SLR Project No.: 233.V65441.00001

**RE: Final EIS Addendum for Elite Development Lands East of Port Colborne
SLR Response to Agency Comments**

PROJECT: EIS Addendum for Elite Developments East of Port Colborne

TITLE: **Natural Heritage Constraints and Development Limit**

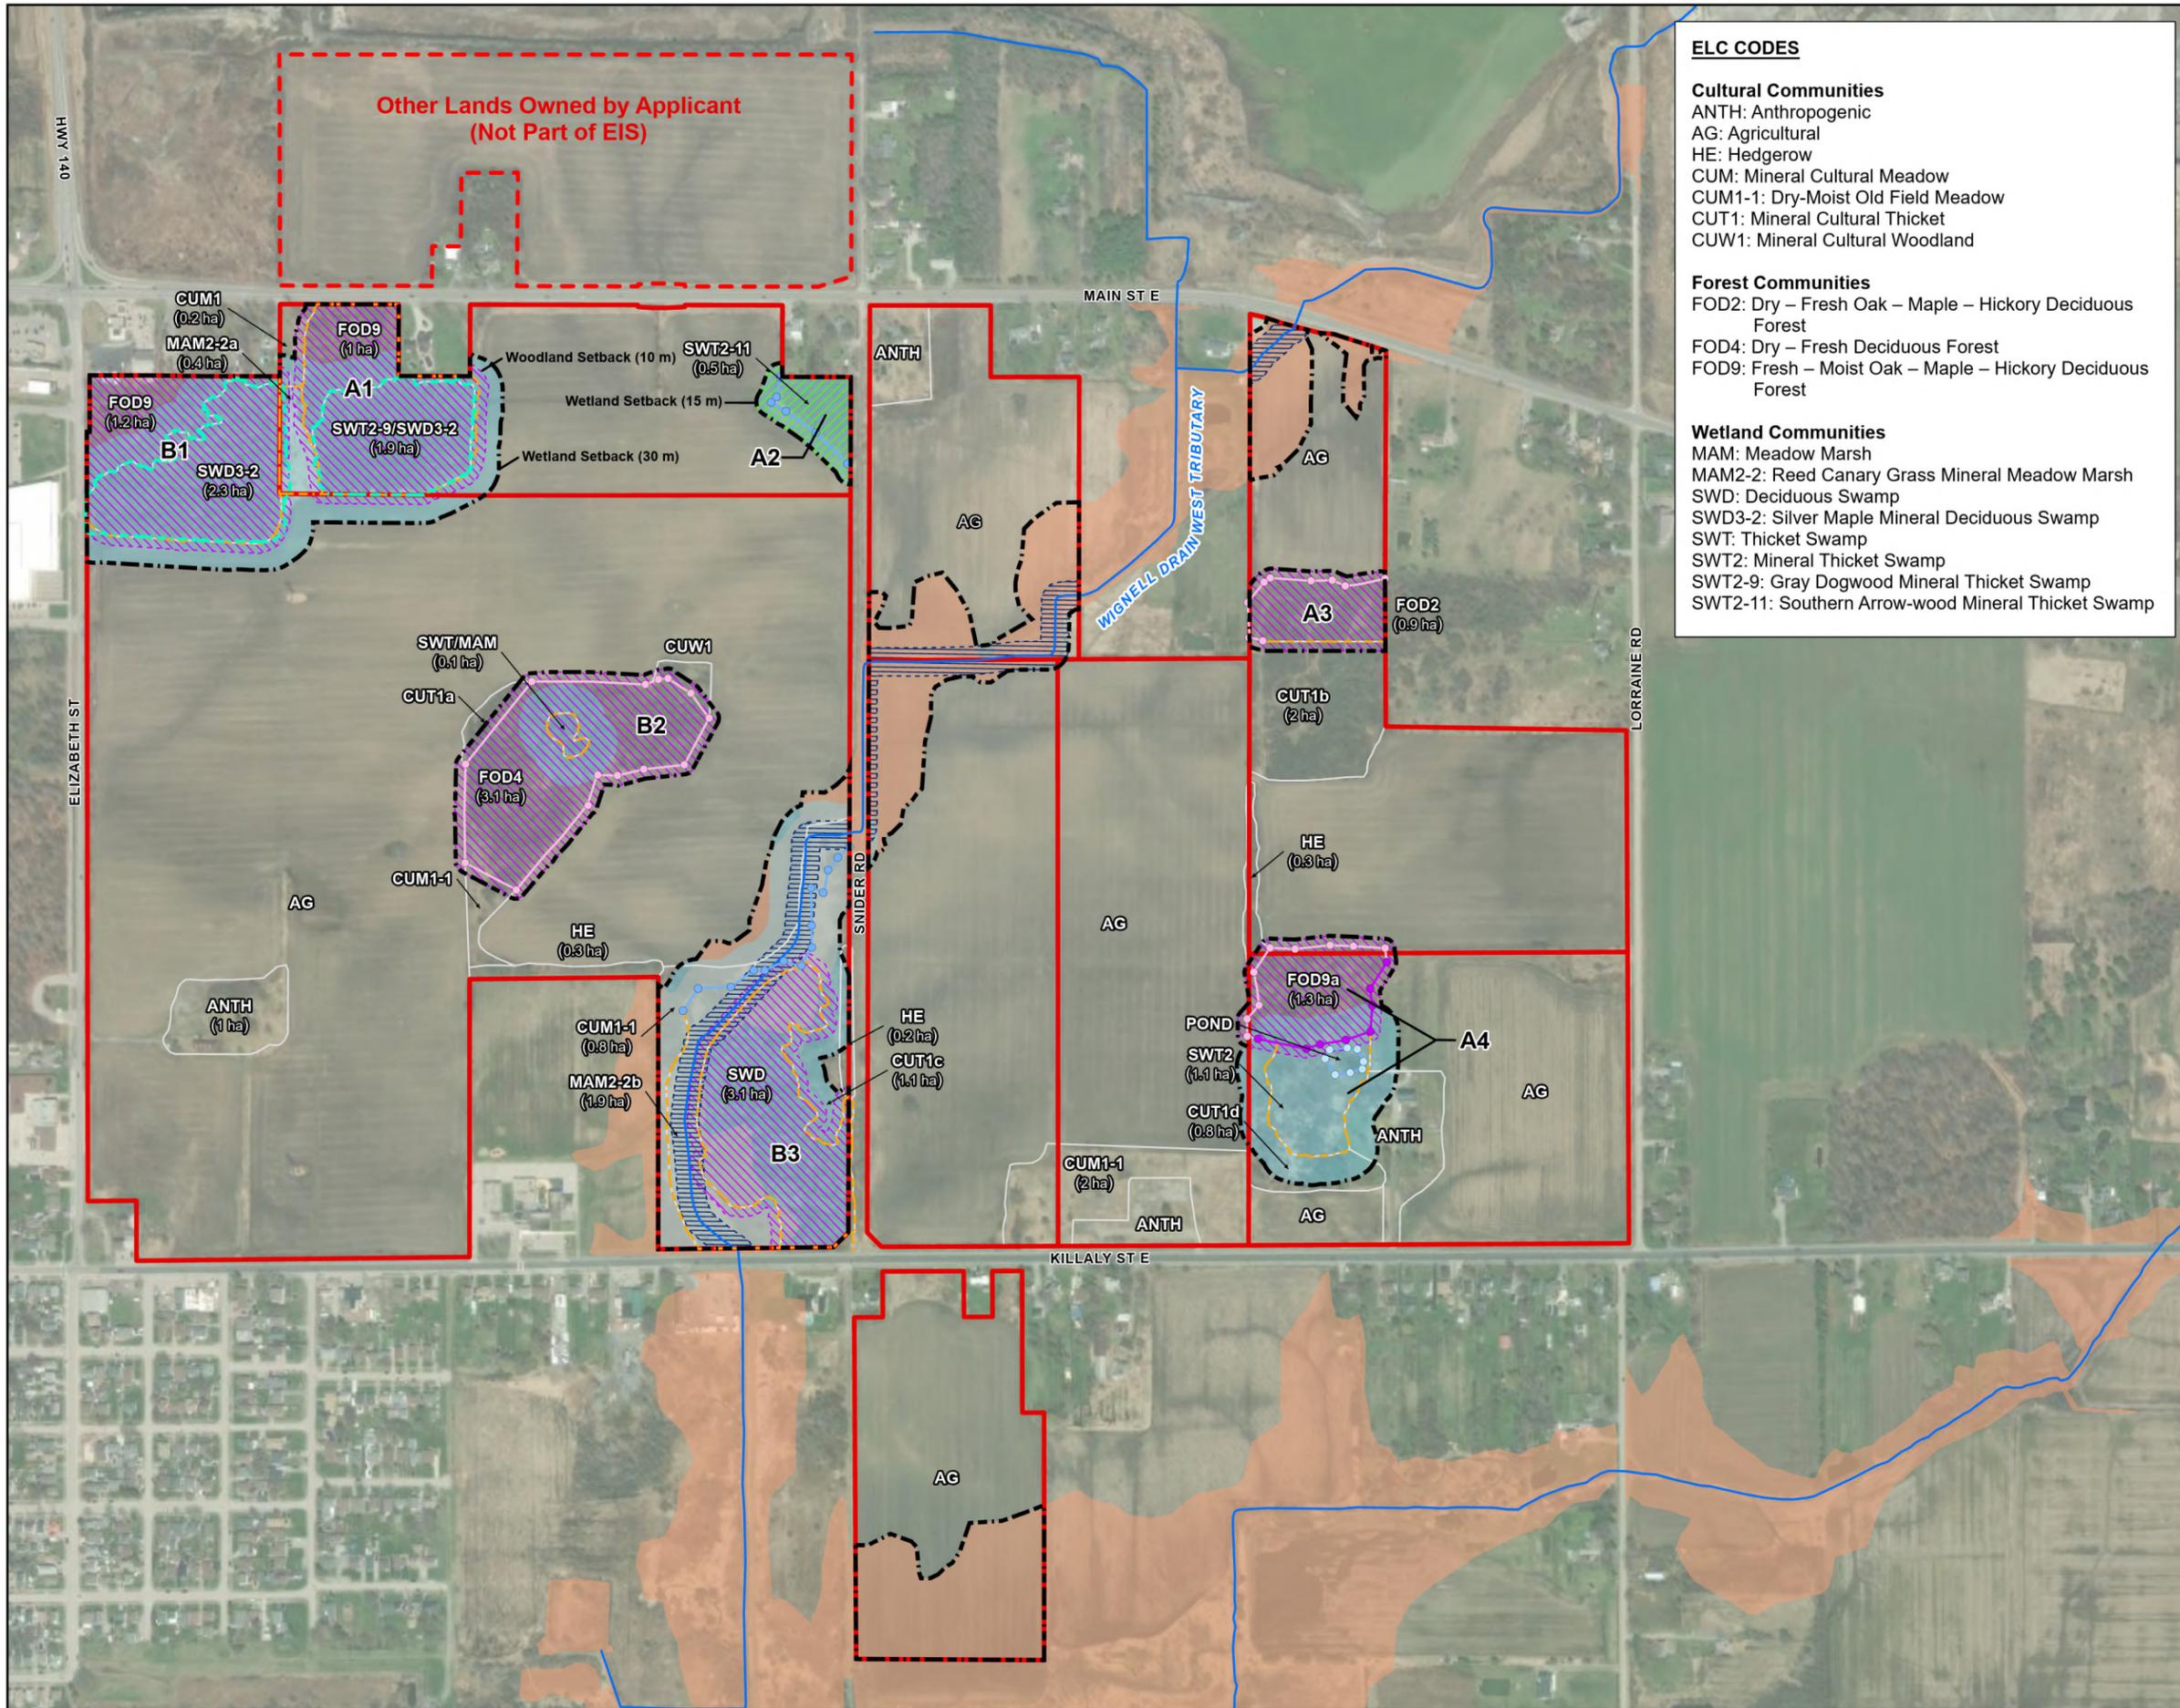
2.73 The SWS indicates that local linkages should be a minimum of 60 m wide as a target. However, the EIS outlines that 20 metres is sufficient for the subject lands. Please elaborate on why the EIS recommendations are inconsistent with the recommendations of the SWS. Further, staff note that Stormwater Management ("SWM") blocks are being utilized to provide connectivity in the Draft Plan: however, as SWM ponds are considered infrastructure, there are likely conflicts with wildlife that require further consideration (e.g., how do you mitigate amphibians and reptiles from accessing SWM infrastructure?)

2.74 The EIS recommends minimum 15 m buffers adjacent to the municipal drain that traverses the property. However, the drain corridor was also identified as providing an ecological connectivity function. Consistent with the recommendations outlined in the SWS, the ecological connectivity of almost every southern Ontario landscape can be improved through a combination of creating larger natural areas or widening connections in a variety of directions between existing natural areas (i.e., watercourses). The SWS states that all watercourses within the Study Area are also areas of potential future natural connection. As such, staff request that consideration be given to larger buffers adjacent to watercourses on the subject lands, and if no changes are recommended that justification be provided.

Regarding wildlife connectivity between upland and wetland habitats, it should be noted that of the seven areas of natural heritage (labelled A1 to A4 and B1 to B3 in the EIS, see Figure 5), only one wetland (A2) does not connect to an upland area. This area (A2) does not have substantive standing water after spring and thus any breeding amphibians would be able to use A2 as an upland area during the non-breeding season. Thus, all the breeding amphibians recorded in wetlands B1, B2, B3, and A2, and A4 can already easily reach suitable non-breeding, upland habitat.

SLR consider the proposed buffers to the municipal drain to be very functional given that the corridor associated with the drain is at a minimum 30 m wide (based on the 15 m drain/watercourse buffer on either side). In many places within the subject lands, the corridor will be much wider than this. In the northern two-thirds of the subject lands the floodplain generally exceeds the 15 m buffer.

Consequently, the corridor is variably between 50 to 100 m in total width. In the southern third of the subject lands there is a woodland/wetland area that widens the corridor to create a natural area that is about 250 m in width. For the types of species utilizing their areas for movement, SLR is strongly of the opinion that this linkage is functional and appropriate.

Wignell Drain was shown on EIS figures based NPCA Ontario drain/watercourse mapping which was in part incorrect east of Snider Road. This may have occurred because of historical changes to straightened watercourses. Figures 5 (Natural Heritage Constraints and Development Limit) and Figure 6 (Proposed Development) have been updated using current (LIO 2020) drain/watercourse mapping (and confirmed with Odan/Detech and SLR aquatic staff) and the January 29, 2026, Conceptual Master Lotting Plan. The 2024 SWS contained correct Wignell Drain mapping.

Proposed Enhancement and Compensation Areas

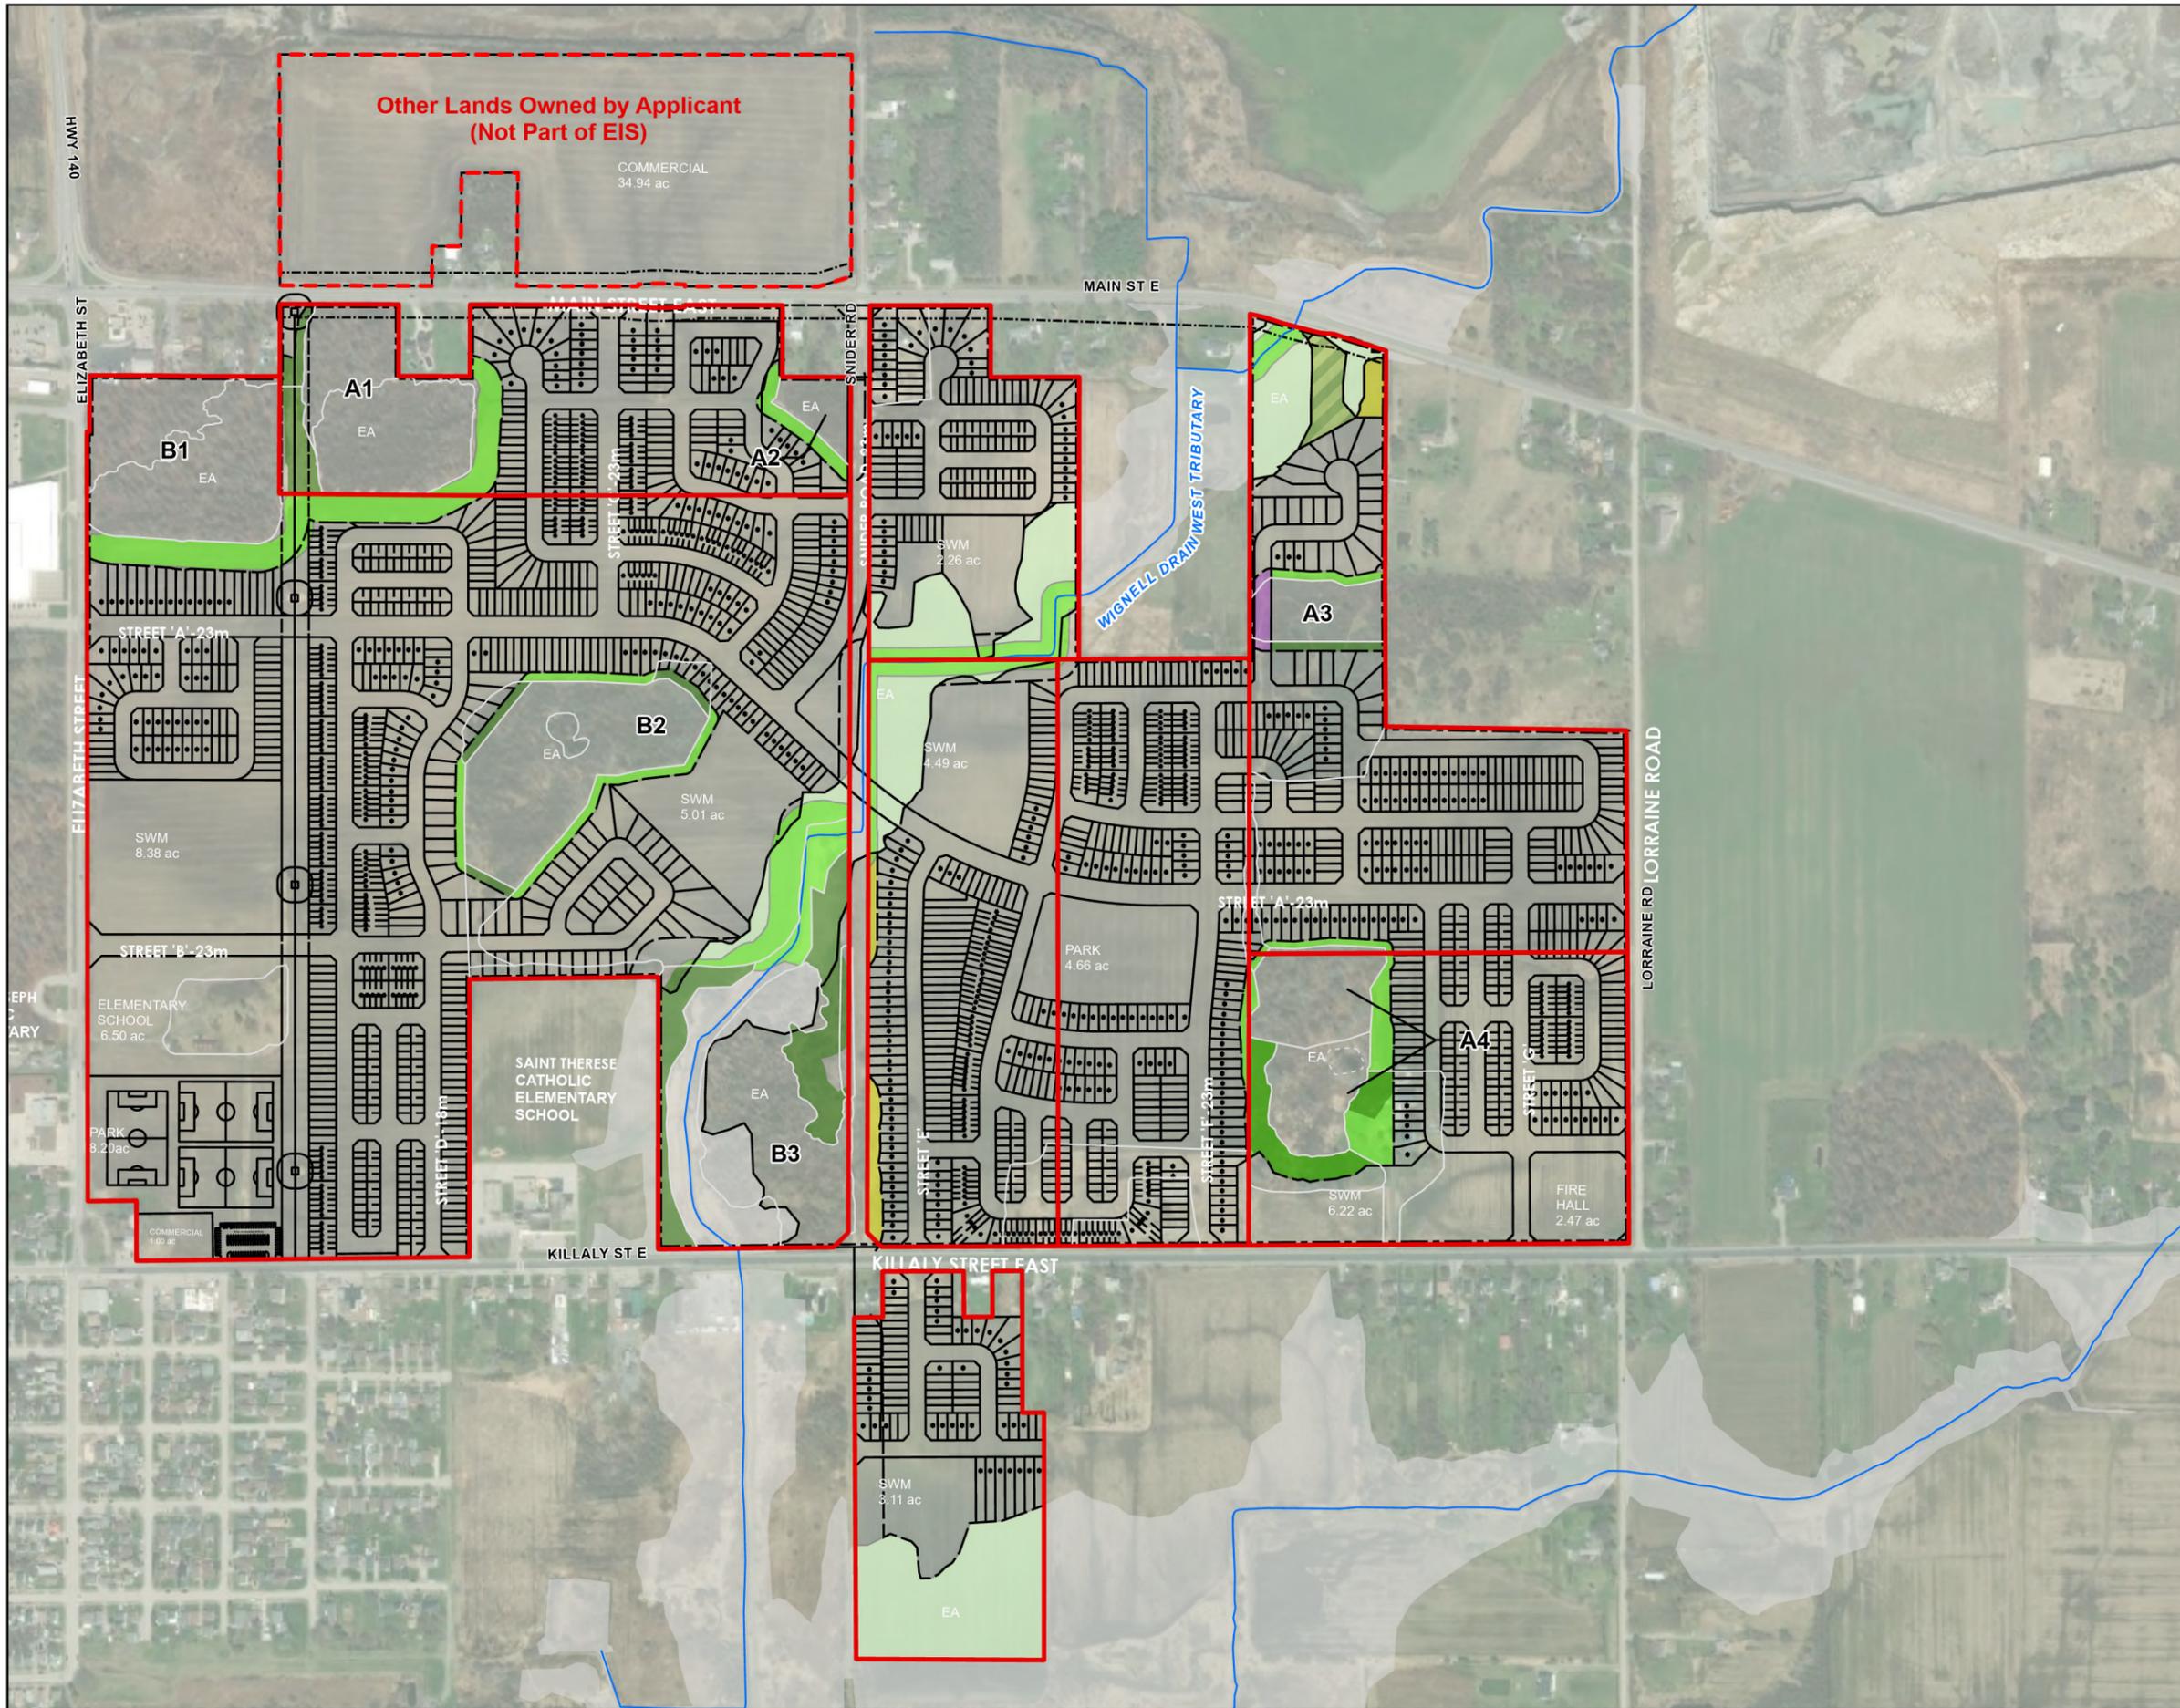
2.77 Staff note that the EIS does not assess 'supporting area and features' or 'enhancement areas', as required by NOP policies. Please include specific sections related to both in an EIS Addendum.

There will be proposed ecological connections (of no set width) using stormwater management facilities (SWMF) between: a) B2 and B3 woodland/wetlands, b) B1 to off-site areas and c) A4 to off-site areas (see Figure 7). All of these SWMF are anticipated to have naturalized areas and dry/wet forebay areas that wildlife might use. The second two are considered potential connections because the building of new road underpasses, under Elizabeth St. and Killaly St. E respectively, would be necessary to make the connection complete. Eco-passages would be expected to be built at a time of road reconstruction, subject to the completion of an environmental assessment and design feasibility for the proposed road improvements.

As noted in the EIS, Section 7.2.8, the Client is proposing to enhance all parts of the floodplain (which are undevelopable) and buffer areas that are currently within agricultural lands (see Figure 7 attached). This totals an area of 11.71 ha across the subject lands. Figure 7 illustrates the 5.83 ha of enhancement areas in buffers (bright green) and a 5.88 ha floodplain enhancement area (pale green). This enhancement would use a native species seed mix combined with small clusters of native woody species plantings to improve the natural diversity and function of the floodplain. Through time, these woody species would spread. Woody species that could be planted are listed in Section 7.2.8 of the EIS. If left unseeded or unplanted the floodplain would likely self-seed with 'weedy' herbaceous plants that would primarily be non-native. The areas in Figure 7 that are depicted by the darkest green are buffers that currently contain meadow or thicket species or scattered trees and do not need to be planted.

In order to compensate for this 0.18 ha of woodland loss, it is proposed that a larger (0.35) ha piece of (potentially developable) land to the north of this will be planted in compensation. The restoration occurring here will differ from other restoration in that it will be planted much more densely with woodland tree species.

A new figure (Figure 7) has been created to indicate areas of compensation and enhancement (restoration). This shows there are three types of areas for restoration: woodland compensation, buffers, and floodplain. Not all buffers are shown as restored areas because these buffers already contain naturalized areas (i.e., meadows and thickets - dark green buffers). In some places, these buffers could be improved ecologically. Specifically, in the area around B2 woodland there is a considerable amount of invasive Common Buckthorn; we recommend that this is improved by removing some of the buckthorn and replacing with native species.
